**Assessment of Parking Lot  
Subsurface Conditions  
Jabulani Winery and Event Facility  
8005 Jock Trail  
Ottawa, Ontario**

GEMTEC Project: 101593.001

April 25, 2023  
GEMTEC Project: 101593.001

**Re: Response to Comments from the City of Ottawa**  
**File No. D07-12-22-0113**  
**Dated November 29, 2022**

Date	JULY, 2022	Rev.	0	FIGURE 1
------	------------	------	---	----------

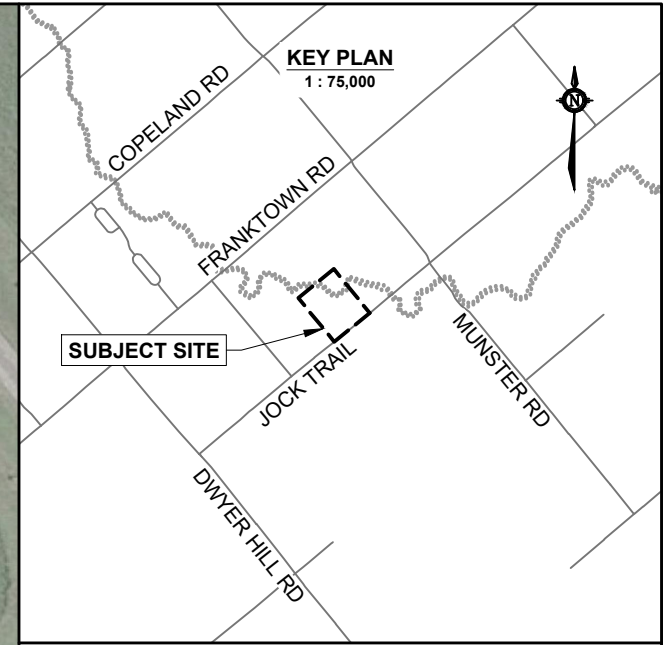
The City states that “it seems that recommendations regarding the required minimum granular thickness should be that of the fire truck access route of 380 millimetres”. The Gemtec report states that the Granular Base Equivalency (GBE) for fire truck access routes should be about 380 millimetres. The GBE and granular thickness are not the same. Reference should be made to Table 3.3.5 of the Ontario Ministry of Transportation Pavement Design and Rehabilitation Guideline Manual, Second Edition, 2013, for Granular Base Equivalency Factors Guidelines. It should be noted that Table 3.3.5 does not distinguish between Granular B Type I or II, nor does it provide an equivalency for well shattered blast rock. It has been our experience that an equivalency factor of 0.85 is reasonable for Granular B Type II (100 percent crushed) and well shattered blast rock.

**Item 37**

We have reviewed the Site Plan prepared by ZanderPlan, File No. 22-077, dated February 13, 2023 which, identifies the location of the fire truck route. There are to be three signs installed at the northwest corner of the parking lot which identify the parking area for the fire trucks. The fire trucks are to enter the site off of Jock Trail, travel straight towards the walkway and then turn to the left and park in front of the signs. Test pit numbers 22-02, 22-03, 22-04 and 22-05 are representative of the expected parking lot granular thicknesses. It is noted that the GBE at test pit 22-02 is deficient for heavy truck traffic purposes. The GBE at test pits 22-03, 22-04 and 22-05 is considered to meet or exceed the required GBE for fire and other heavy truck traffic.

It is pointed out that in order to improve the site drainage, Shade Group Inc. have indicated that the grade in the vicinity of test pit 22-02 will be raised by at least 300 millimetres. Provided that granular material meeting OPSS specifications for Granular A is used to raise the grade, the minimum GBE requirements for fire truck and other heavy truck traffic will be achieved. This will therefore satisfy the requirements for the granular structure along the proposed fire route. It is also understood that as part of the overall grading improvements at this site additional granular material is to be added to the parking lot area. This will further improve the overall GBE of the parking area.
